# Interim Reclamation and Stormwater Inspection

Operator: UPLAND EXPLORATION LLC- #10701

Location ID: 456651

Inspection Photos  
Location Name: Salt Ranch Fee/18 East  
Location ID: 456651

**Photo 6.** Photo taken from western fill slope, facing East. Photo illustrates sediment laden stormwater discharging off location (red arrows).

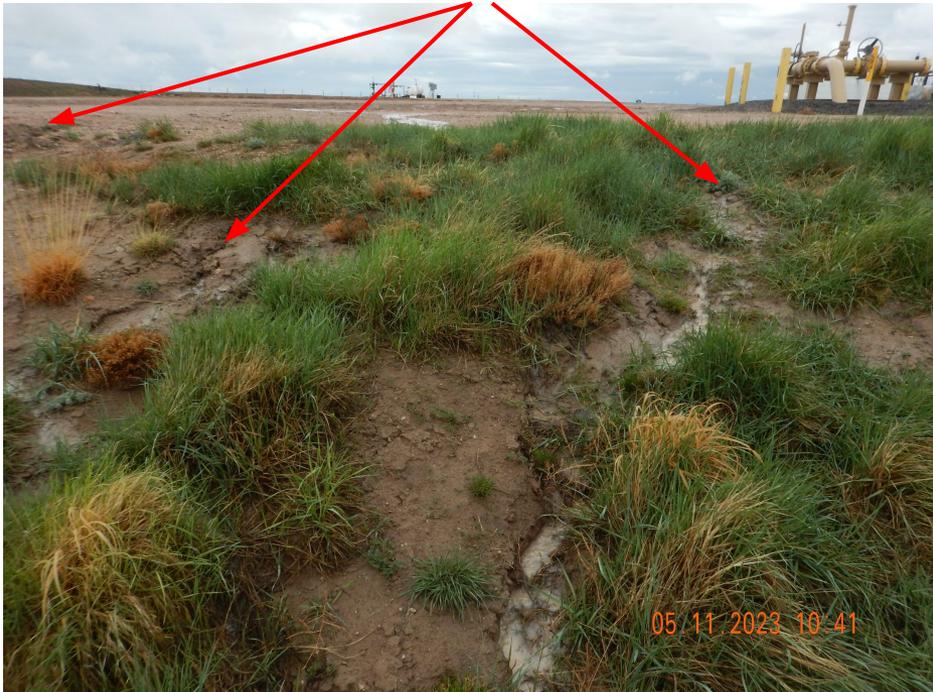
Note- there was no perimeter BMP at the base of the fill slope.
